# Timing diagrams

Miklos Lukacs (Silicon Labs) | 20 May 2016

# Autoclass timing

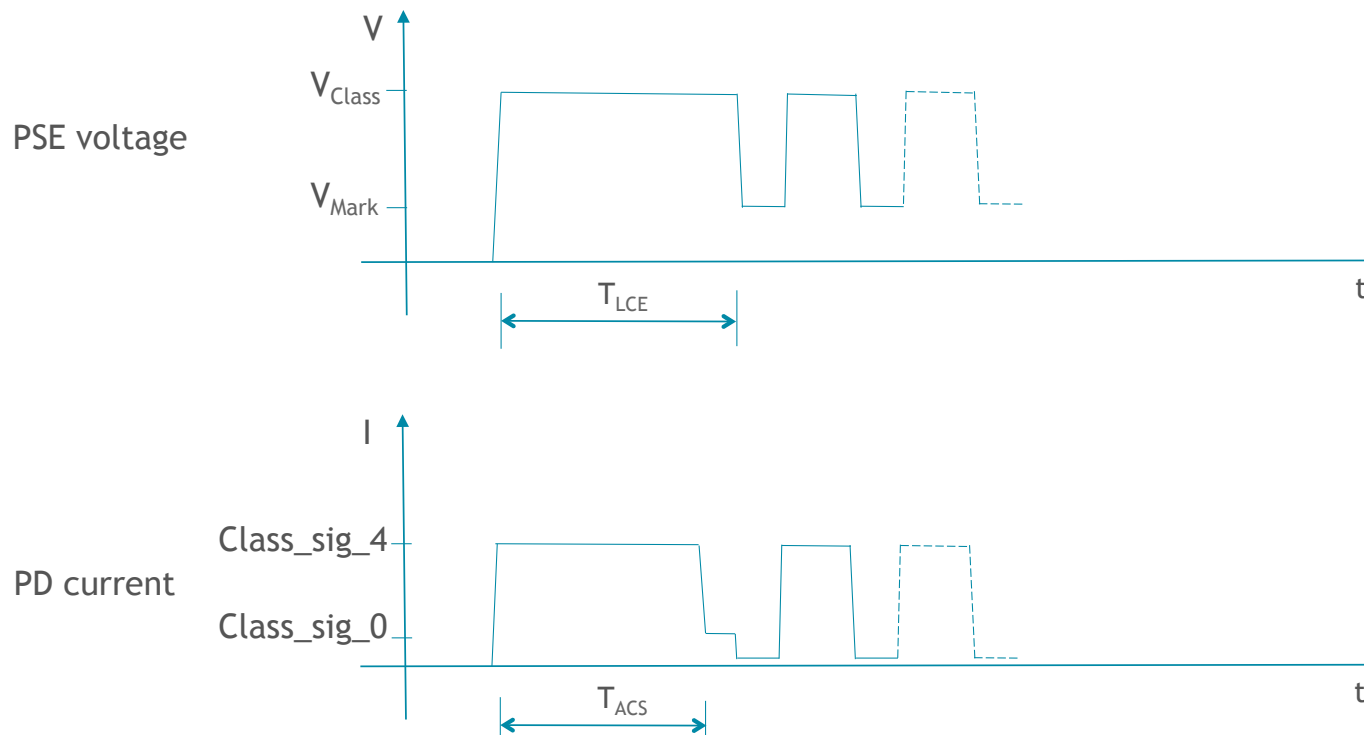
comment #63

- Into section 33.2.5.11 PSE Type 3 and Type 4 functions: do\_autoclassification
  - Type 3 or Type 4 PSE and PD autoclass example

# Connection Check sequence diagrams

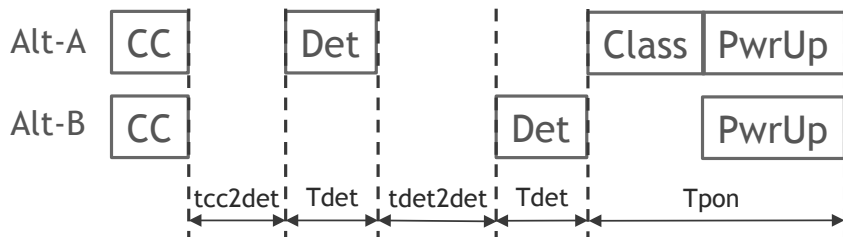
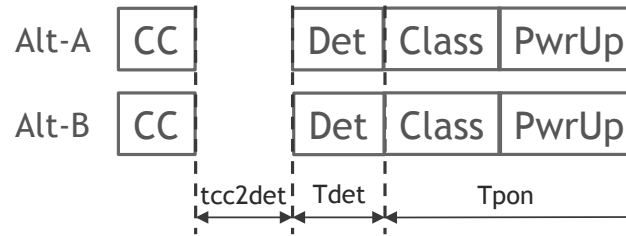
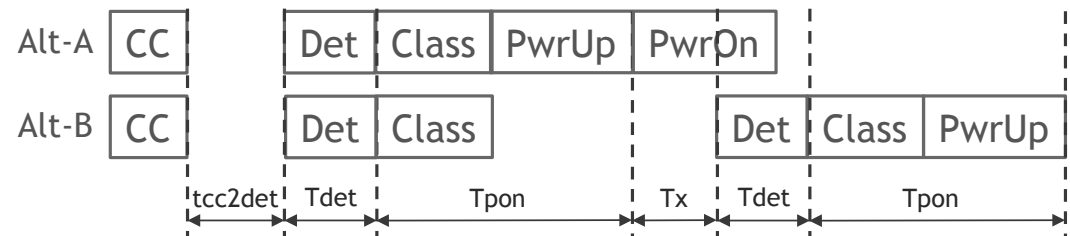
comment #64

- After CC\_DET\_SEQ constant description in section 33.2.5.8
- CC\_DET\_SEQ = 0

- The Alternatives are interchangeable
- Tx is application dependent

# Connection Check sequence diagrams

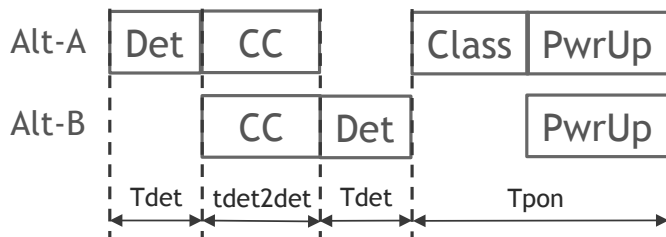
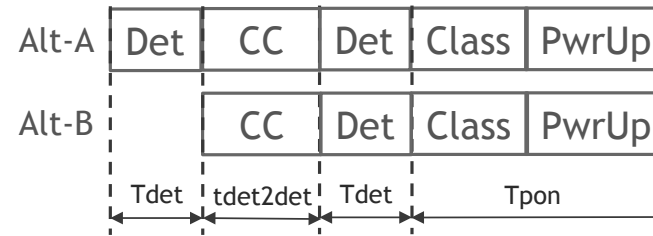
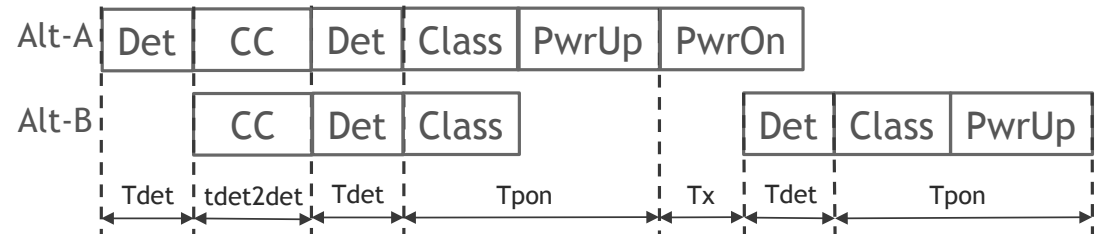
comment #64

- CC\_DET\_SEQ = 1

- The Alternatives are interchangeable
- Tx is application dependent

# Connection Check sequence diagrams

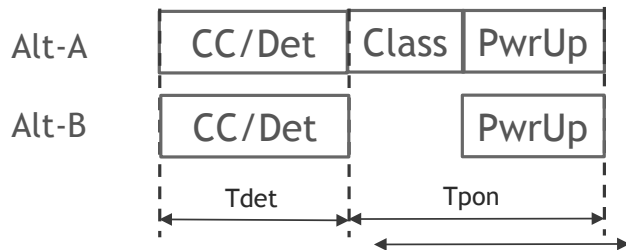
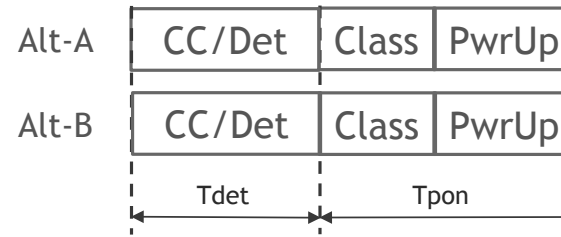
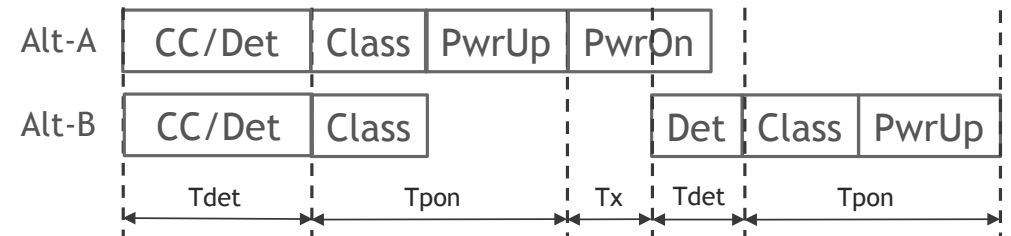
comment #64

- CC\_DET\_SEQ = 2

- The Alternatives are interchangeable
- Tx is application dependent

# Connection Check sequence diagrams

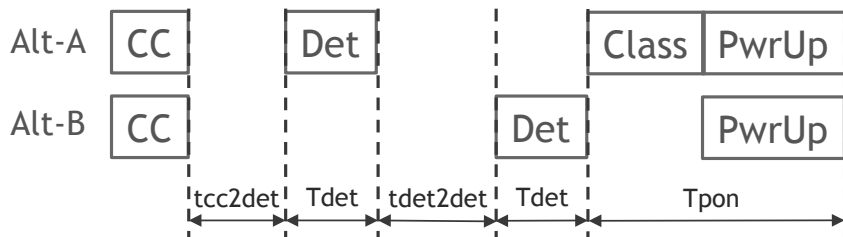
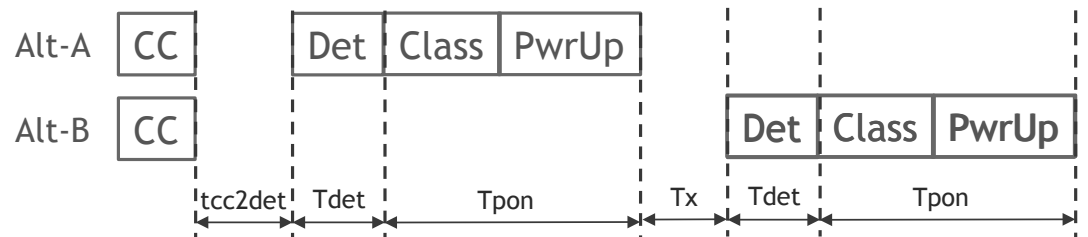
comment #64

- CC\_DET\_SEQ = 3

- The Alternatives are interchangeable
- Tx is application dependent

# Single-Event classification

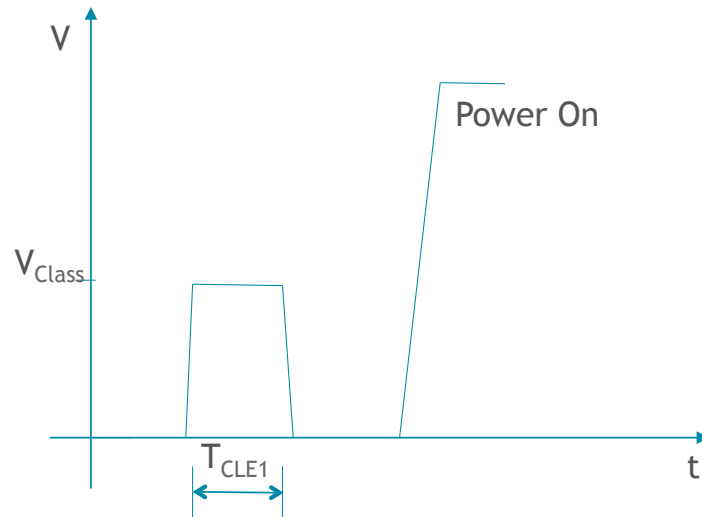
comment #59

- Into section 33.2.7.1 PSE 1-Event Physical Layer classification

# Multiple-Event Physical Layer classification

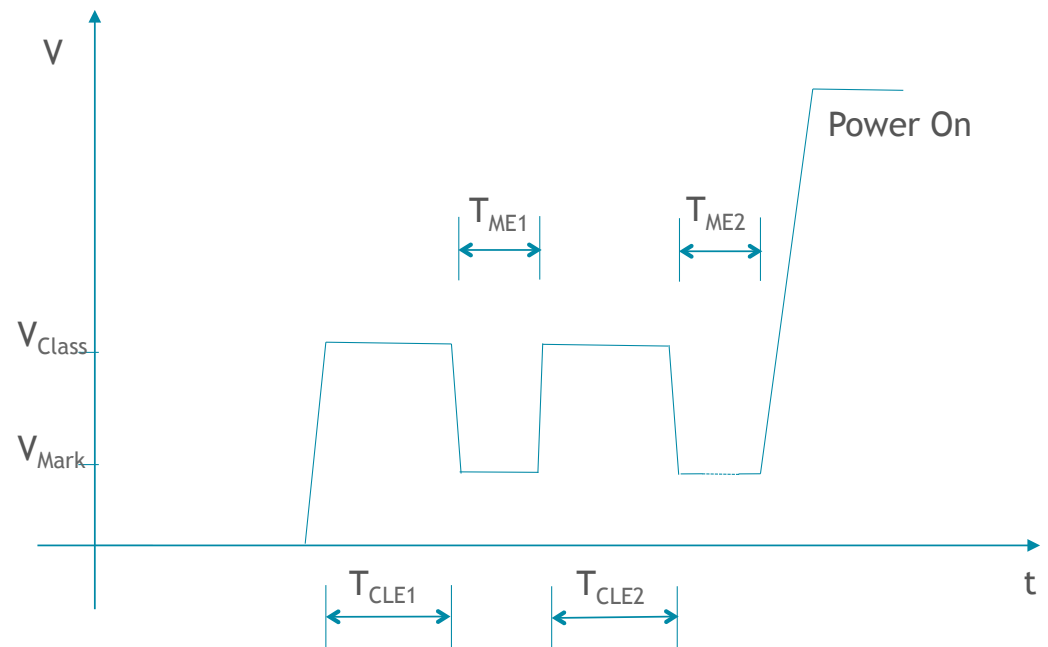
comment #60

- Into section 33.2.7.2 PSE Multiple Event Physical Layer classification
  - Diagram 1: Type 2 PSE - Class 4 PD

# Multiple-Event Physical Layer classification

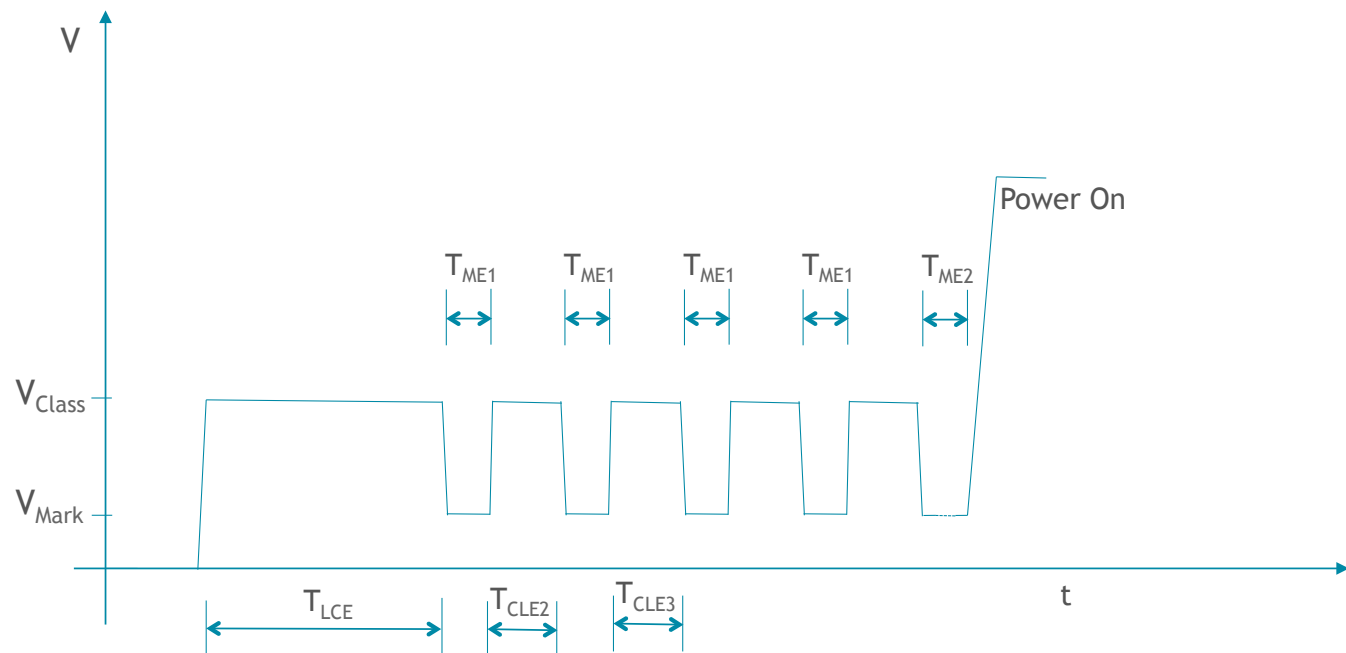
comment #60

- Into section 33.2.7.2 PSE Multiple Event Physical Layer classification
- Diagram 2: Type 4 PSE - Class 8 PD - no autotest
